SUPPLEMENT
16 JULY 1954

SUPPLEMENT TO
TM 11-851
RADIO SET SCR-244-D
AND
RADIO RECEIVERS
R-274A/FRR,
R-274C/FRR,
R-320A/FRC,
R-483/FRR,
AND
R-483A/FRR

The following information, published on Order No. 25693-Phila-53 supplements TM 11-851, October 1953. The equipment covered in this supplement is:

Figure 36.1. Radio Receiver R-620/FRR, schematic diagram of two-stage if. amplifier.

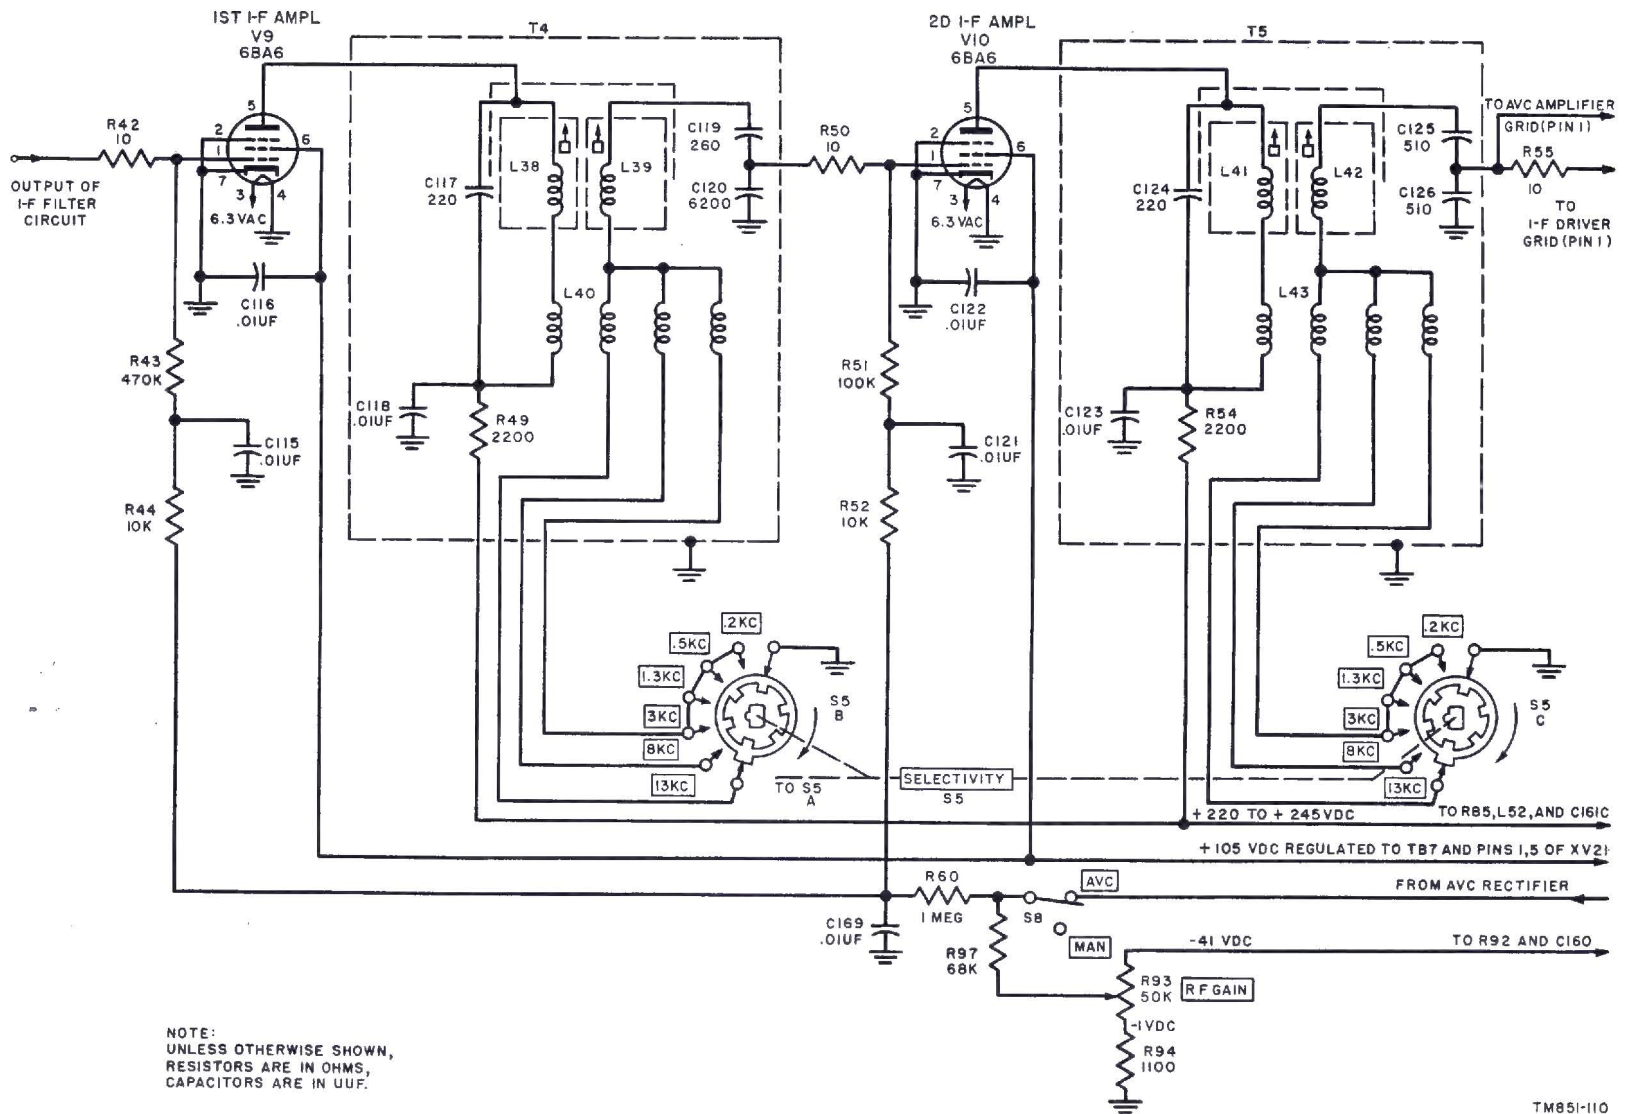
Page 73. Fig. 36. Add figure 36.1 after 36.

Page 74. Par. 64b. Line 14. To sentence ending with "R51" add: (from the junction of R60 and C169 in figure 36.1).

Figure 38.1. Radio Receiver R-620/FRR, schematic diagram of beat-frequency oscillator.

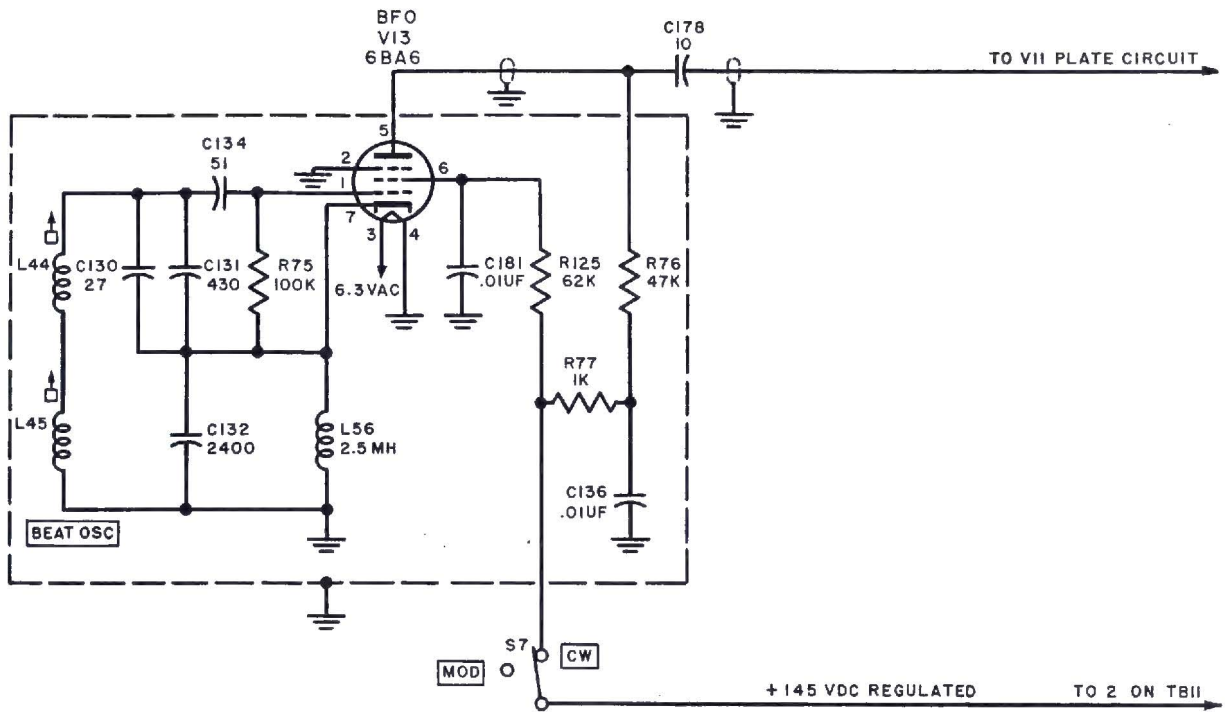
Page 75. Par. 66a. Line 1. To sentence ending in "oscillator" add: (the R-620/FRR receiver contains an electron-coupled oscillator as shown in figure 38.1).

Page 76. Fig. 38. Add figure 38.1 after figure 38.

Page 77. Par. 66c. Line 18. To sentence ending with "circuit" add: (fig. 38);-in figure 38.1, rf choke L56 prevents an rf short across C132.

Page 77. Par. 66c. Add the following to the paragraph: In figure 38.1, the bfo output is fed to the plate of the if. driver V11 through coupling capacitor C178.

Figure 42.1. Radio Receiver R-620/FRR, schematic diagram of cathode follower.

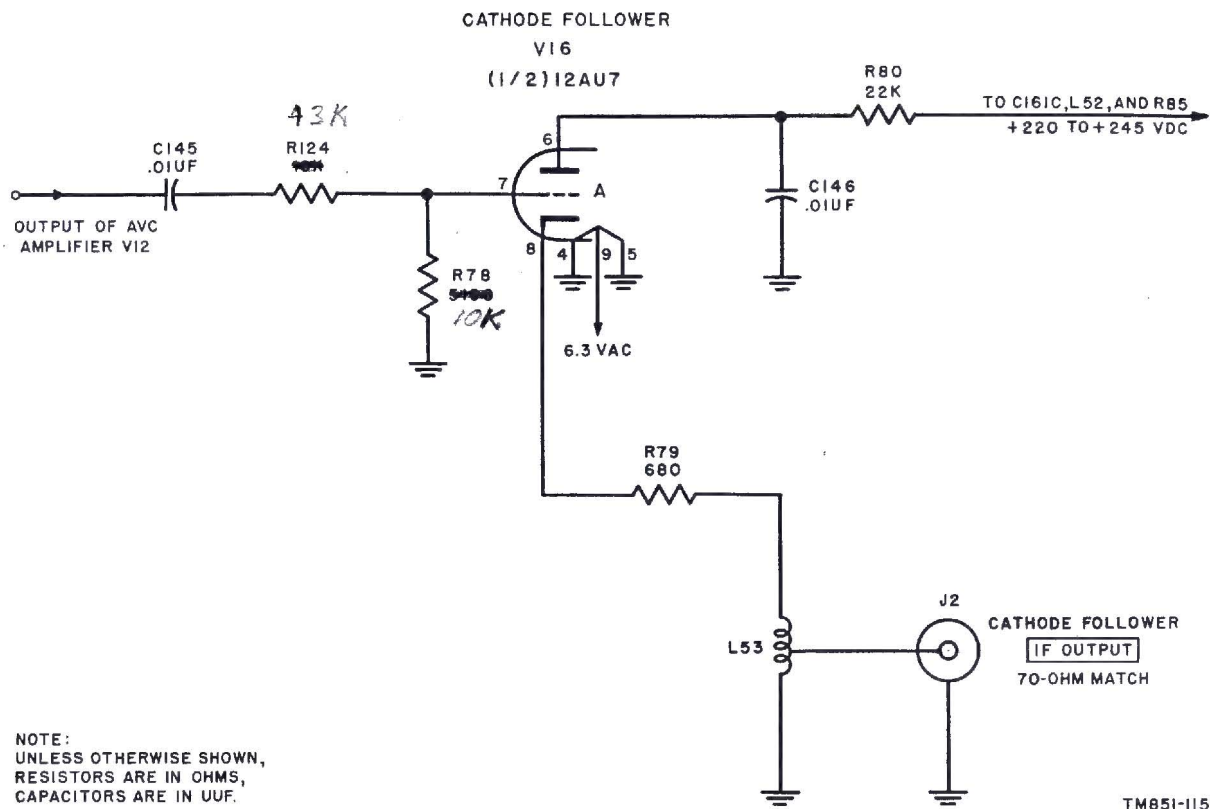
Page 79. Figure 42. Add figure 42.1 after figure 42.

Page 80. Par. 69a. Add the following to the paragraph: In figure 42.1, C147 is not used; but since the tap-to-ground resistance of L53 is low compared to the 70-ohm loading used, the dc cathode current flow to the load is insignificant.

Page 80. Par. 69c. Line 2. After "applicable," add: or from avc amplifier V12 (fig. 42.1).

Page 80. Par. 69c. Line 6. After "C145" add: (and resistor R124 figure 42.1).

Figure 45.1. Radio Receiver R-620/FRR, schematic diagram of avc rectifier.

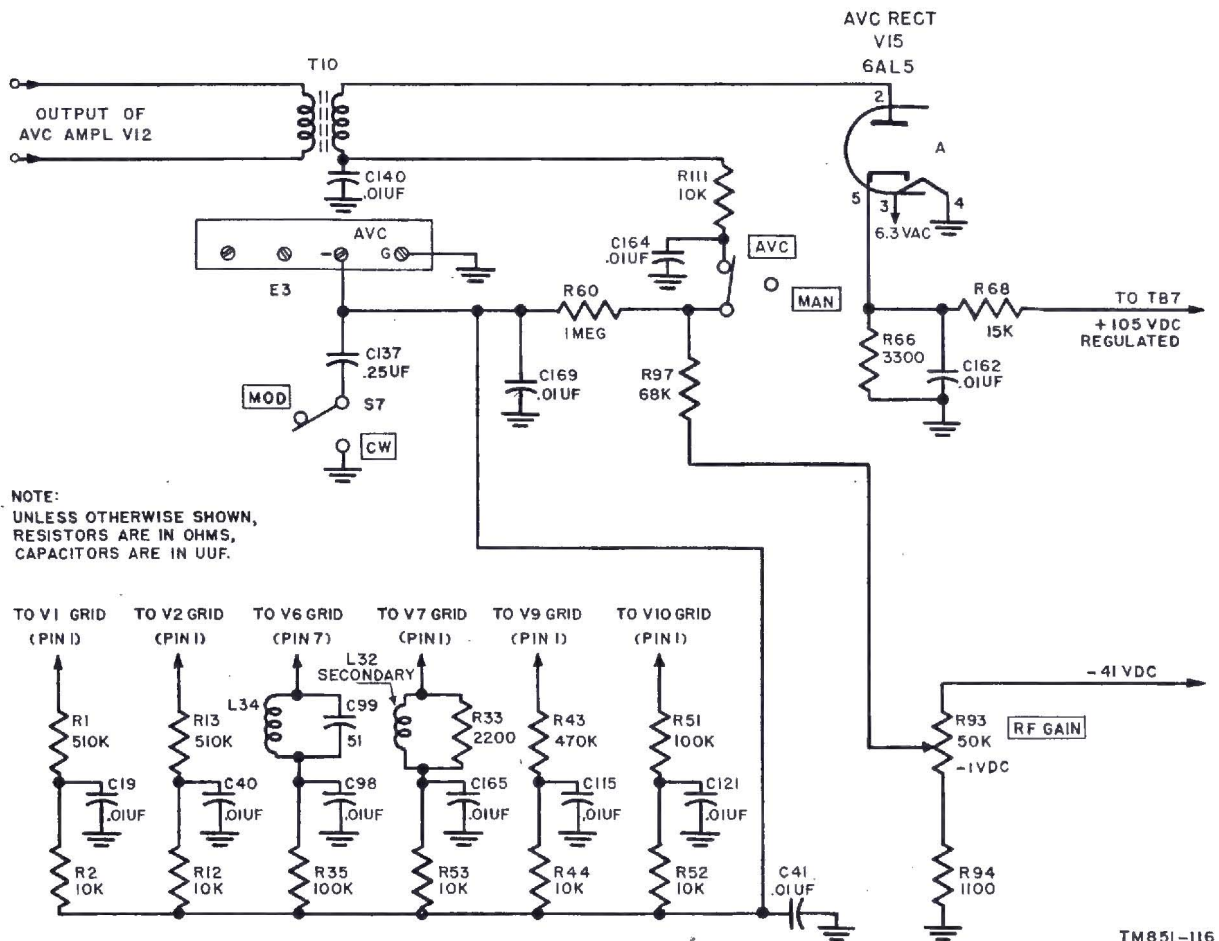
Page 80. Par. 70a. Line 33. After sentence ending with "receiver." add: In figure 45.1, the negative avc bias developed is at the junction of R60 and C169.

Page 81. Figure 45. Add figure 45.1 after figure 45.

Page 82. Par. 70b. Line 6. After sentence ending with "ground." add: In figure 45.1, the delay bias (18.0 volts dc) is obtained from R66 and R68 voltage divider.

Page 82. Par. 70b. Line 7. After sentence ending with "V14B.", add: In figure 45.1, T10 provides for signal coupling.

Figure 46.1. Radio Receiver R-620/FRR, schematic diagram of series type noise limiter rectifier.

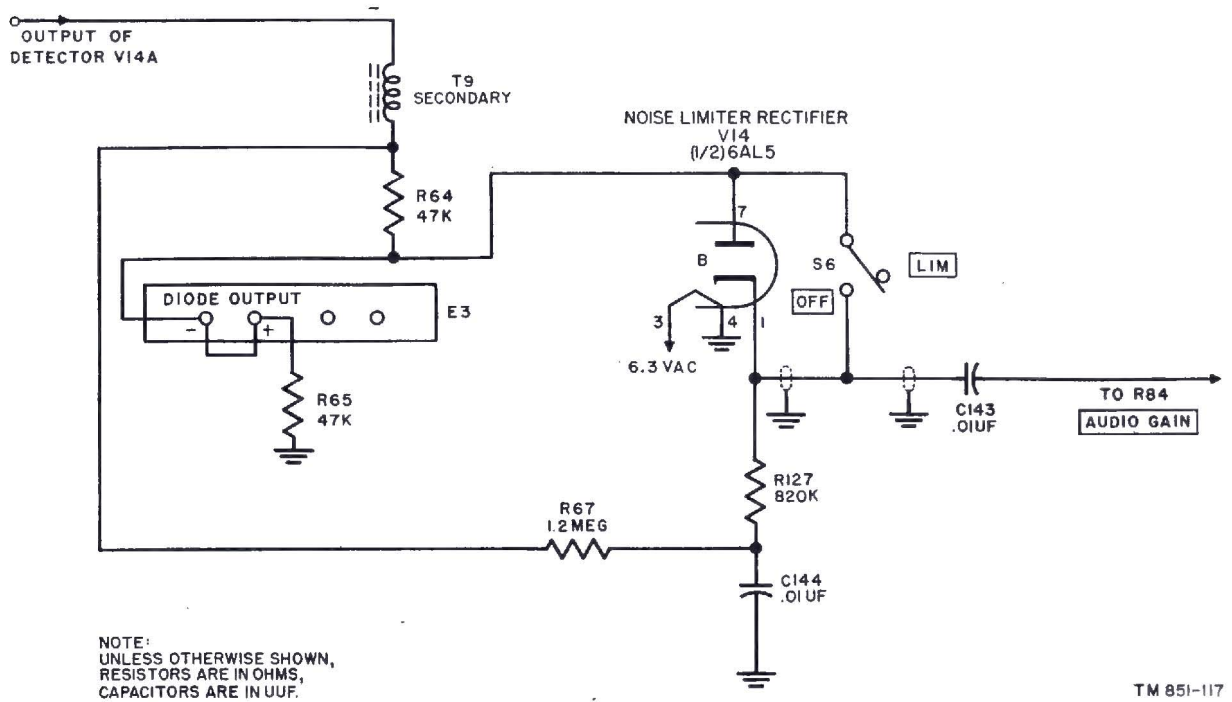
Page 82. Par. 71a. Add the following to the paragraph: In figure 46.1, when S6 is in the LIM position, V14B (series noise limiter) normally conducts. When it stops conducting, it opens the af signal path to C143 and the following stage. The af signal voltage is across R64 and R65.

b.1. In figure 46.1, R64 and R65 are the diode load resistors for the V14A diode detector. The operation of the series noise limiter is as follows: With the S6 LIM-OFF switch in the OFF position, the noise limiter rectifier tube is shorted out. Hence, the audio voltage across R65 is parallel connected across R127 in the cathode leg of V14B through the S6 switch. The audio voltage across R127 is coupled to the grids of the first af amplifier through C143. With S6 in the LIM position, the plate of V14B is connected to junction of R64 and R65. This places a less negative bias voltage on the plate of V14B than exists at the cathode since the bias on the cathode is the full voltage drop obtained across R64 and R65. For example, suppose that the voltage between R64 and ground is -10 volts, this places the cathode at -10 volts with respect to ground and the plate at -5 volts, since this voltage is taken at the junction of R64 and R65. Since the plate of V14B is less negative (or positive) with respect to the cathode, the tube will conduct, its resistance being low compared to other resistance values in the circuit. This effectively connects R127 through the conducting diode to the junction of R64 and R65. Thus, the audio voltage across R65 is passed on through C143 to the grid of the first af amplifier. This audio output is about 45 percent of what it would be without the limiter (due to R64 and R65 voltage divider) but this reduction is of little significance, since it affects only the receiver gain and not the sensitivity. Under the above conditions, C144 becomes charged (the grounded side being positive) through 1.2 megohm resistor R67 which has a relatively large time constant. Any change in potential across C144 would require a considerable amount of time in relation to a change in potential at the plate of V14B. Therefore, if a noise potential of approximately 100 volts suddenly appears across R64 and R65 and brings the plate of the limiter to minus 50 volts with respect to ground, the tube will stop conducting since the cathode cannot follow this instantaneous voltage variation. This in effect, disconnects output capacitor C143 from the junction of R64 and R65 and the af amplifier has no input for the duration of the noise pulse. When the noise pulse has decayed, the original circuit

Page 83. Figure 46. Add figure 46.1 after figure 46.

Figure 47. Radio receiver, all types, schematic diagram of first af amplifier.

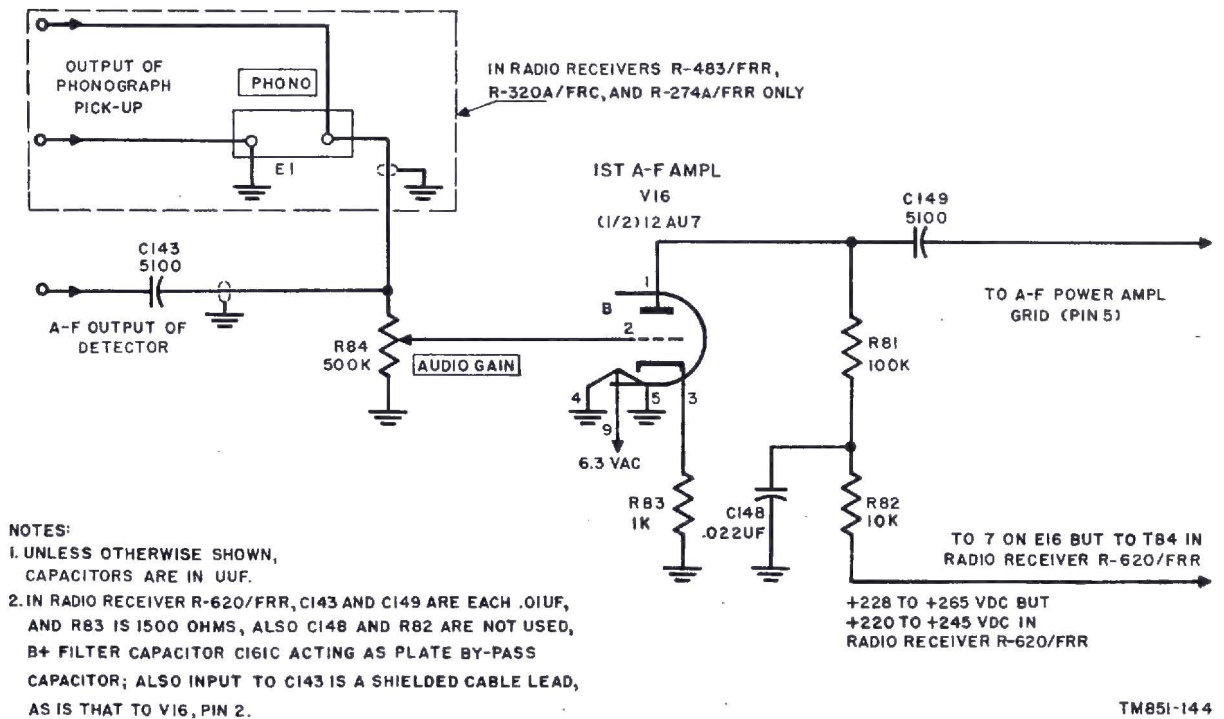
Page 83. Figure 47. Delete figure 47 and substitute new figure 47.

Figure 48.1. Radio Receiver R-620/FRR, schematic diagram of af power amplifier.

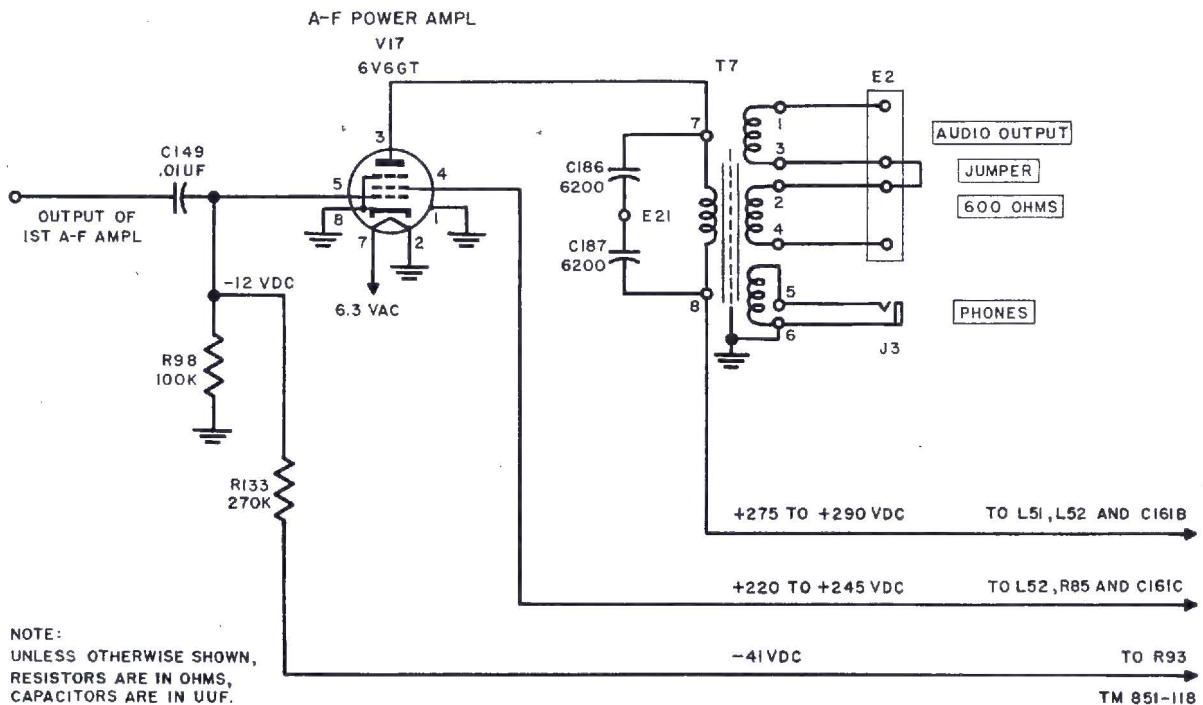
Page 84. Figure 48. Add figure 48.1 after figure 48.

in "E16" add: (fig. 48) from junction L52, R85, and C161C (fig. 48.1).
